NEW BRITAIN - HARTFORD BUSWAY

PERMITTING DRAINAGE DESIGN SUBMISSION

NEWINGTON JUNCTION STATION

State Project No. 88-H039

X-SECTION B-B WATER QUALITY SWALE

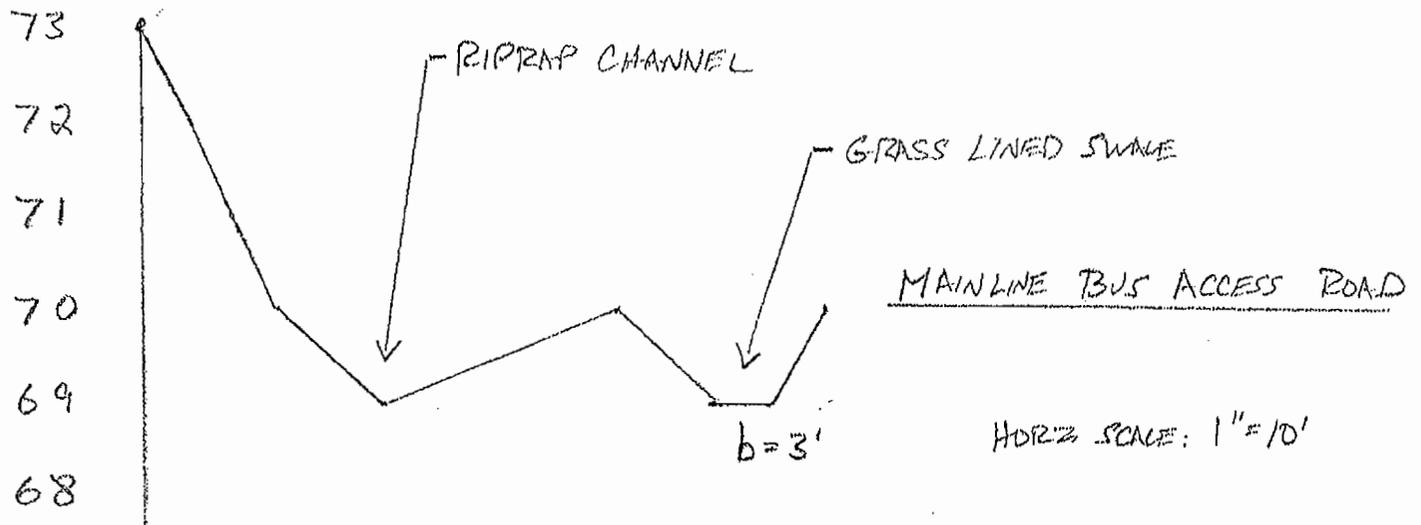
- The angle in which the drainage discharges into the water quality swale should always flow in the direction of the swale. Provide a flared end and MH in order to discharge in the proper direction.

S E A Response: *A manhole has been added, as requested.*

TOWN:
NEWINGTON
 DRAWING TITLE:
**NEWINGTON JUNCTION
 DRAINAGE PLAN**

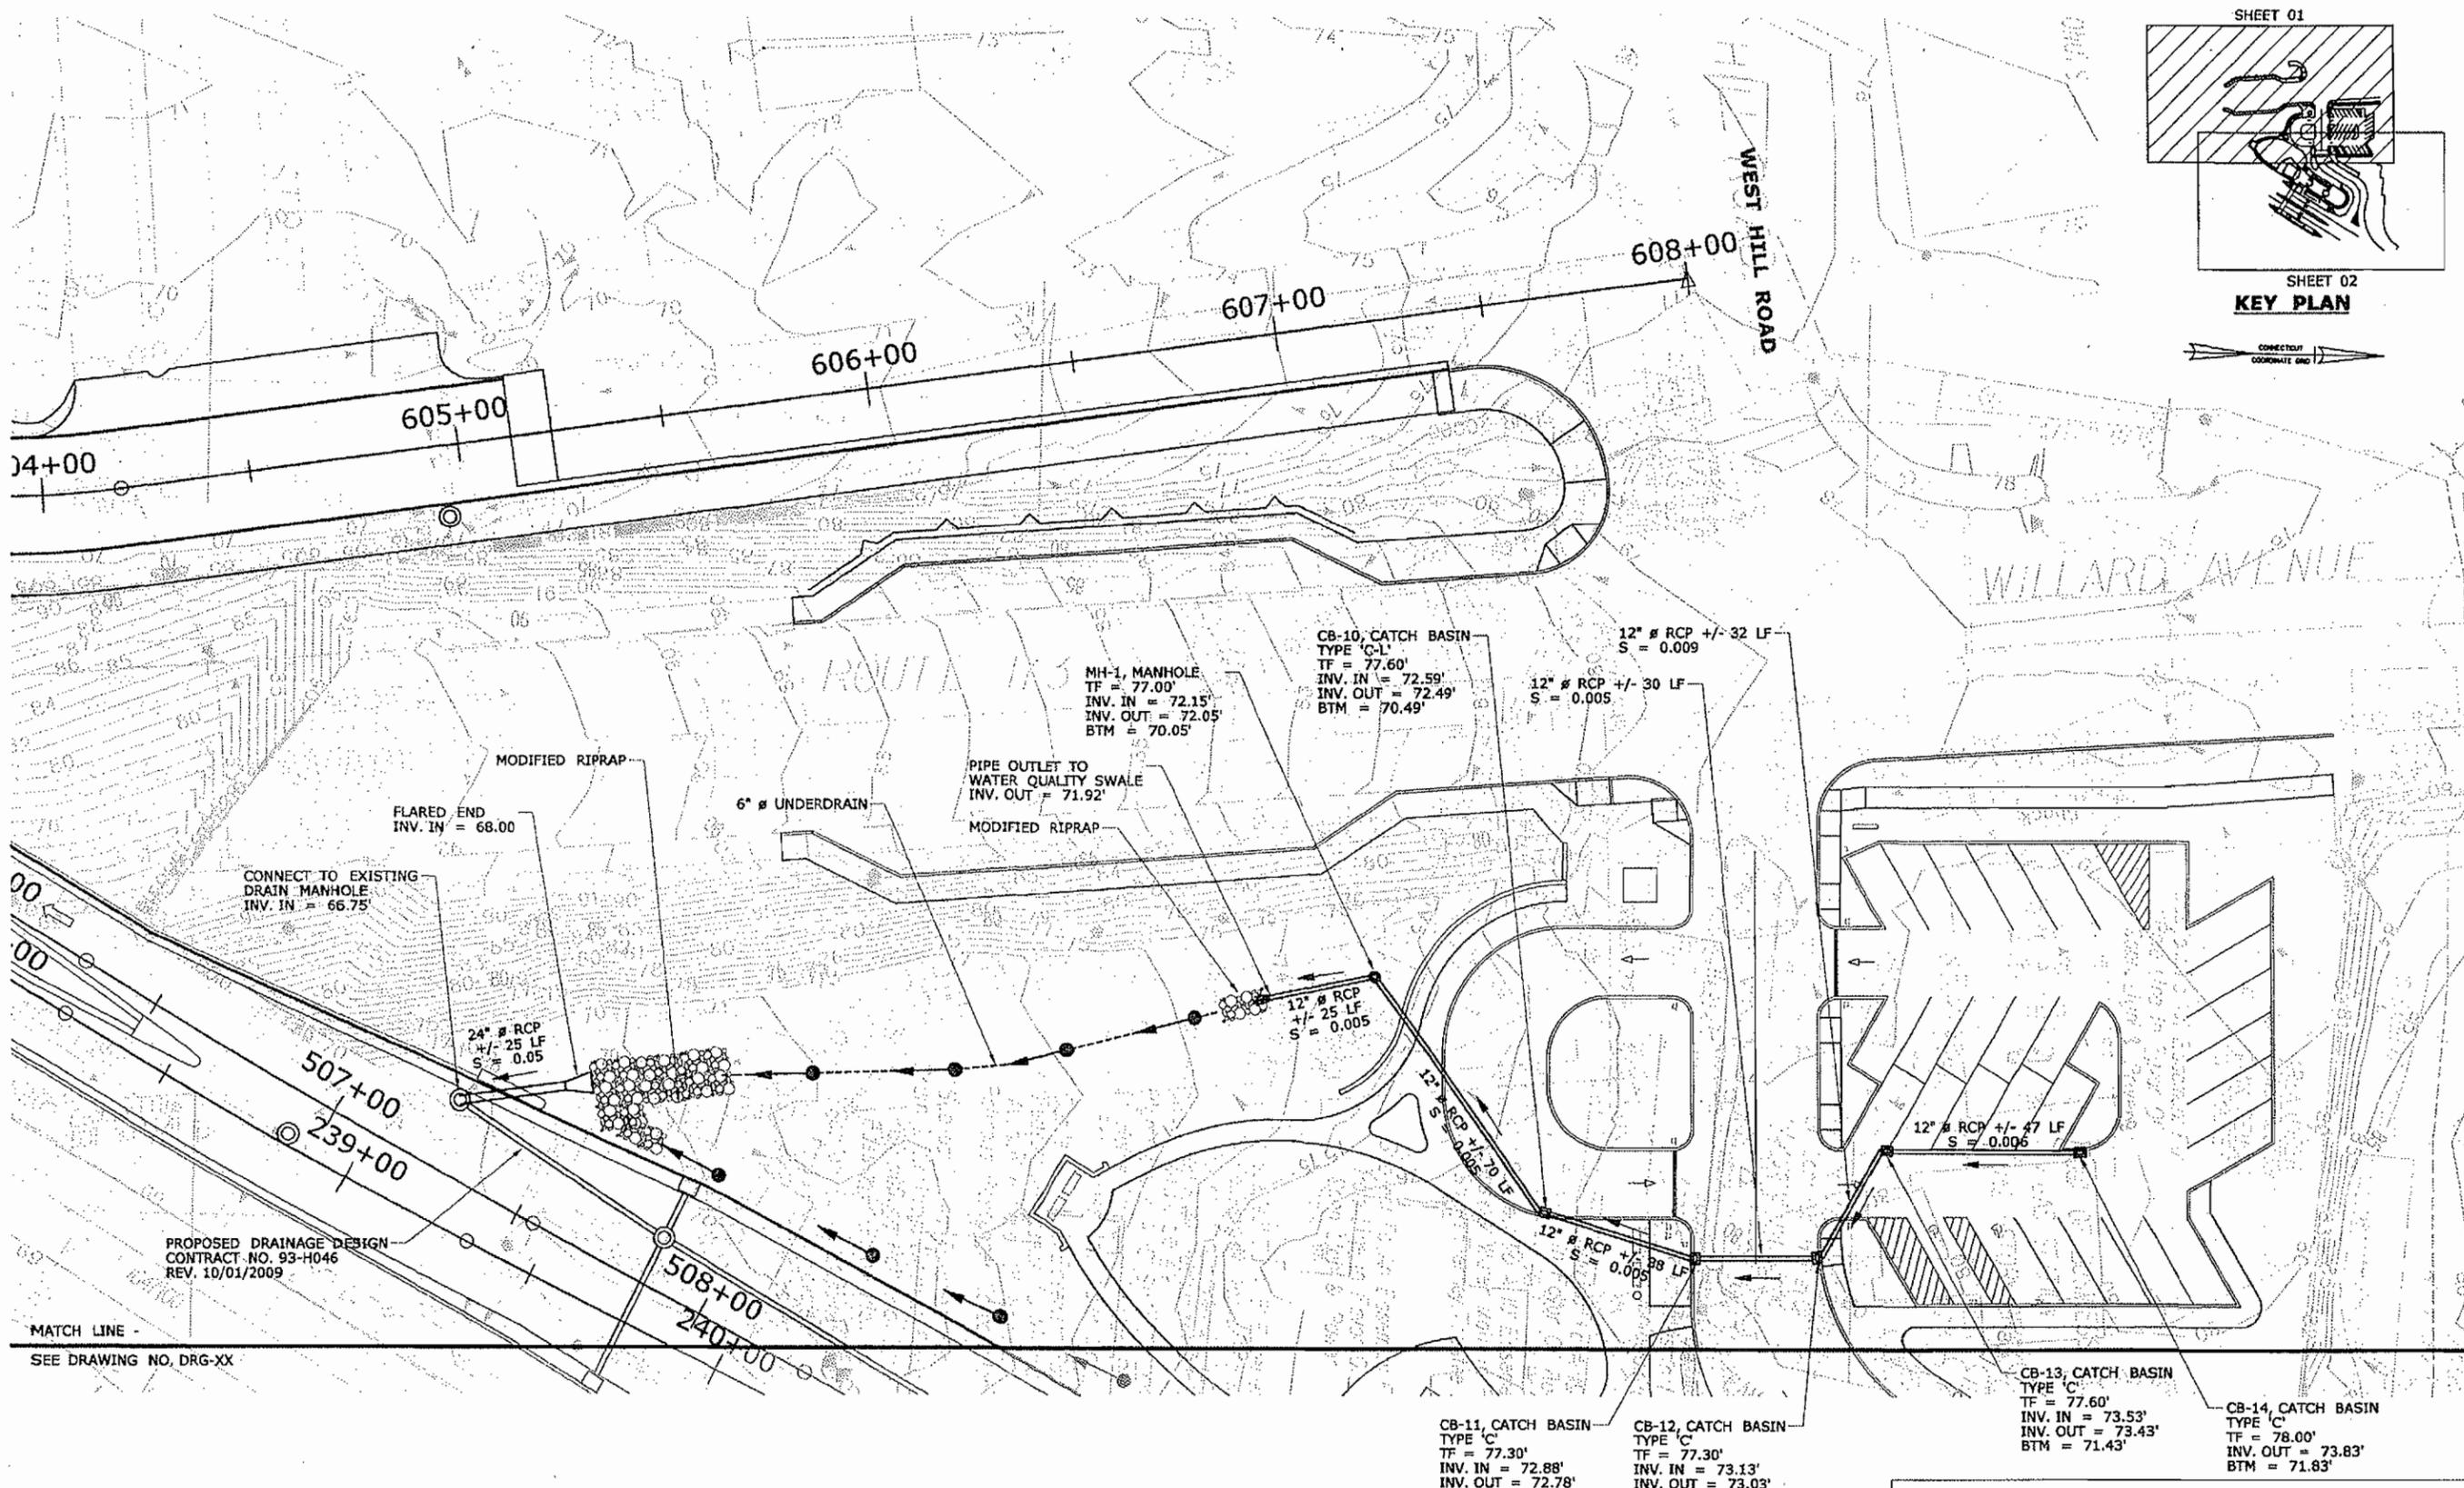
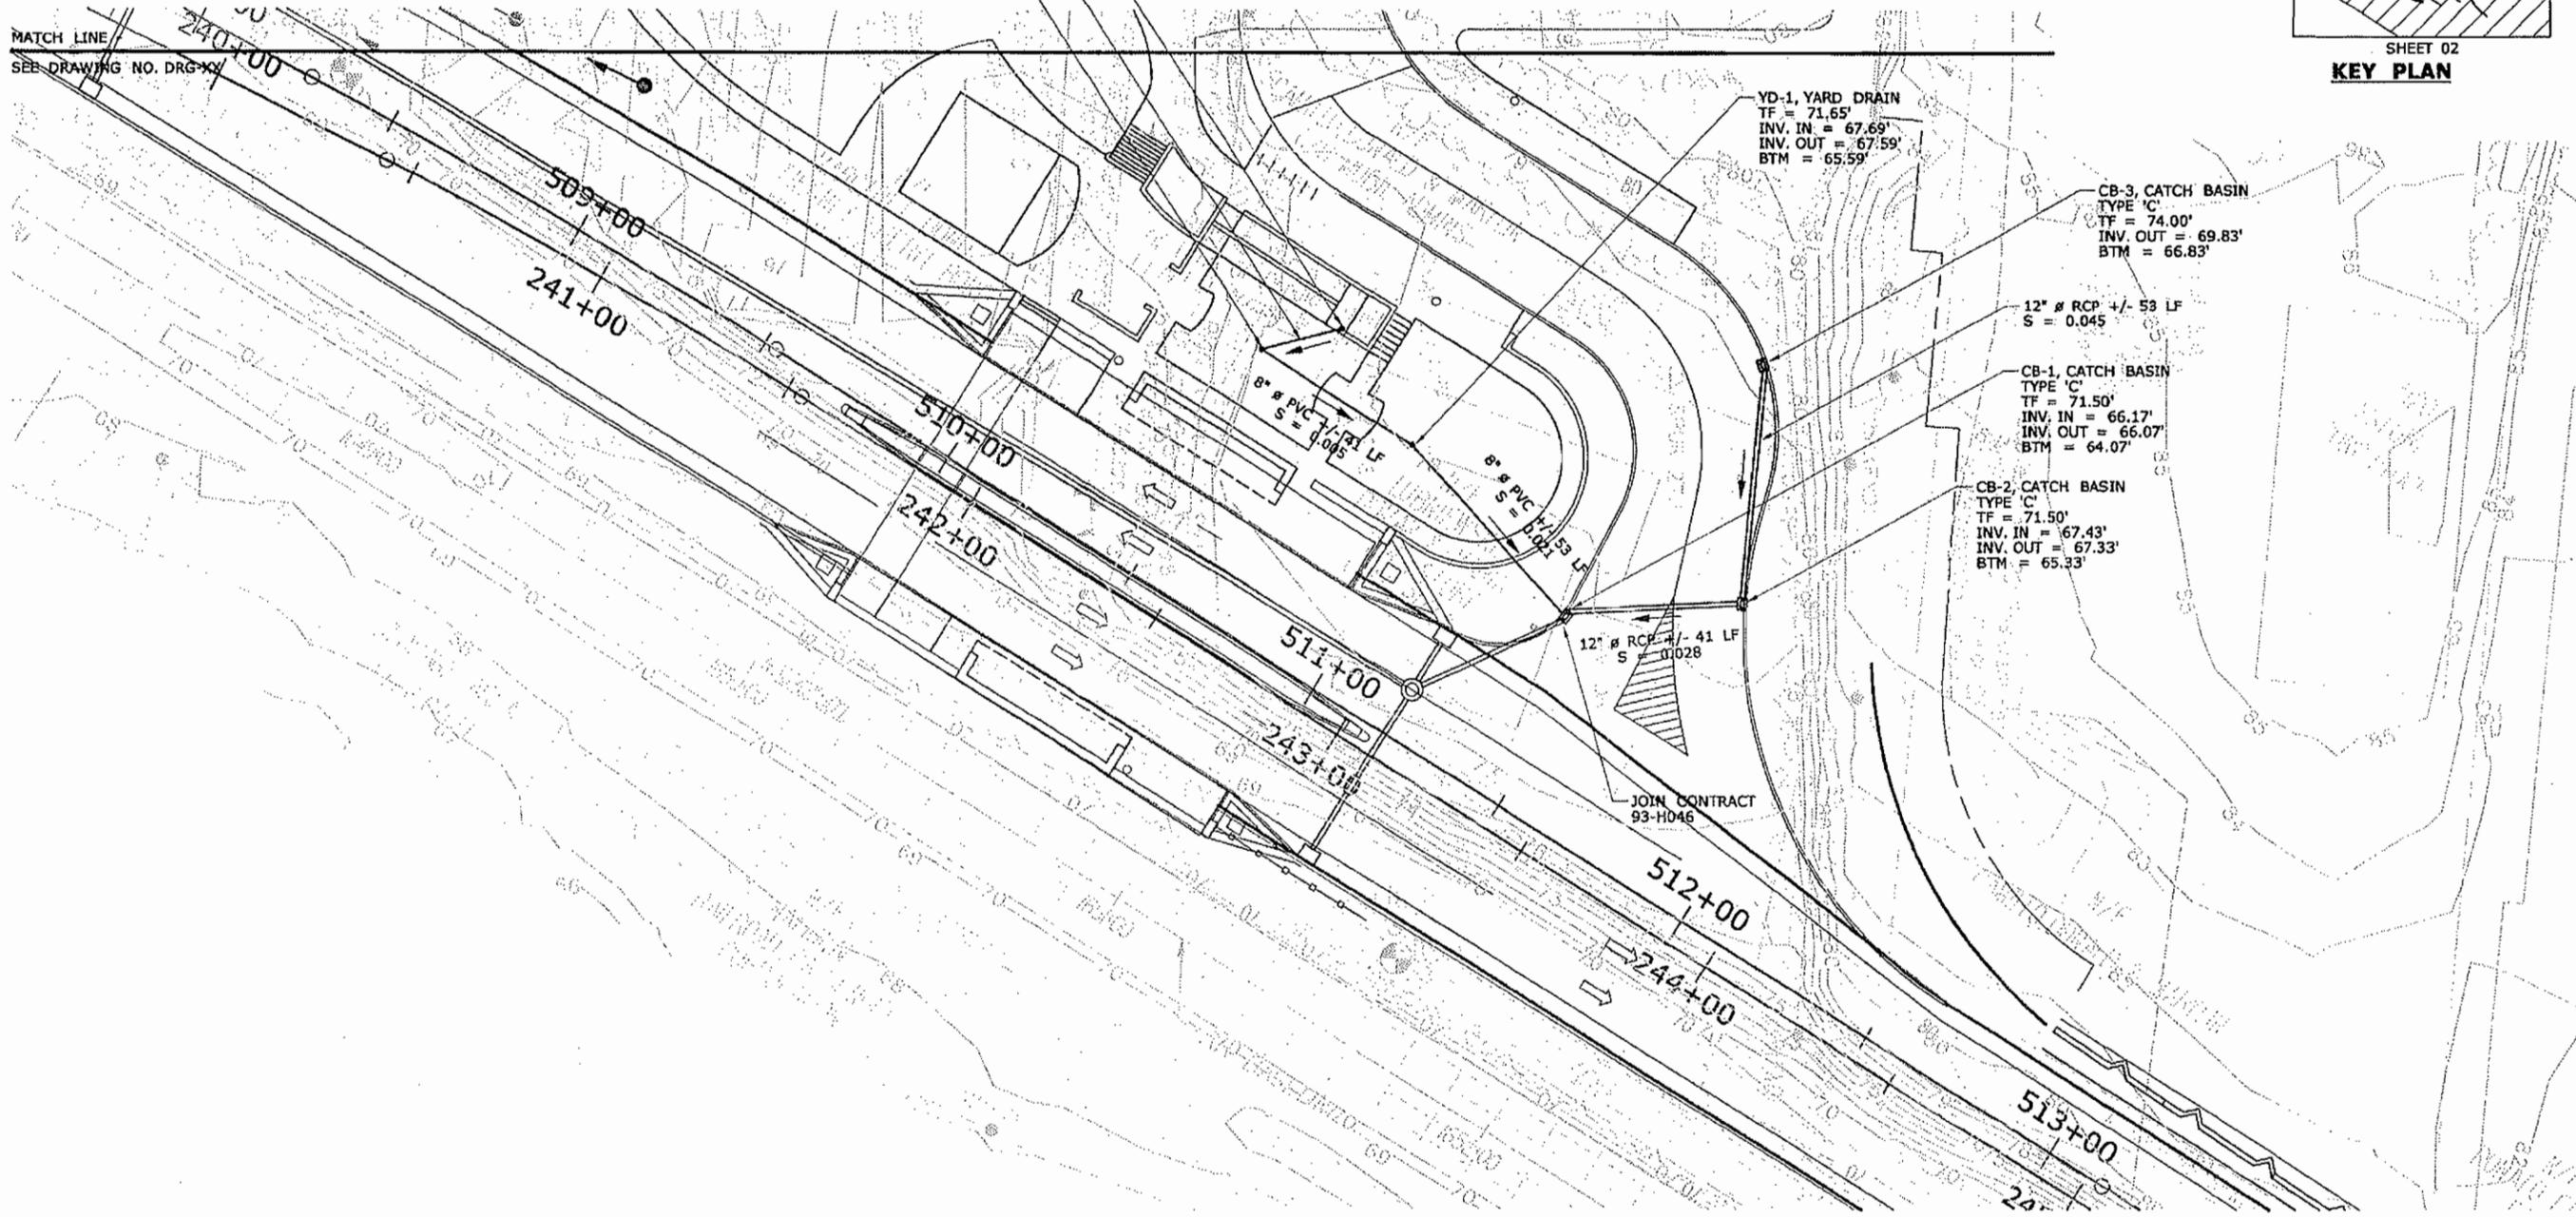
Proposed drainage that is depicted on the plans between the station and the mainline busway project should be differentiated from each other to define the respective project limits.

S E A Response: Additional call-outs have been added to the drainage plan sheets.
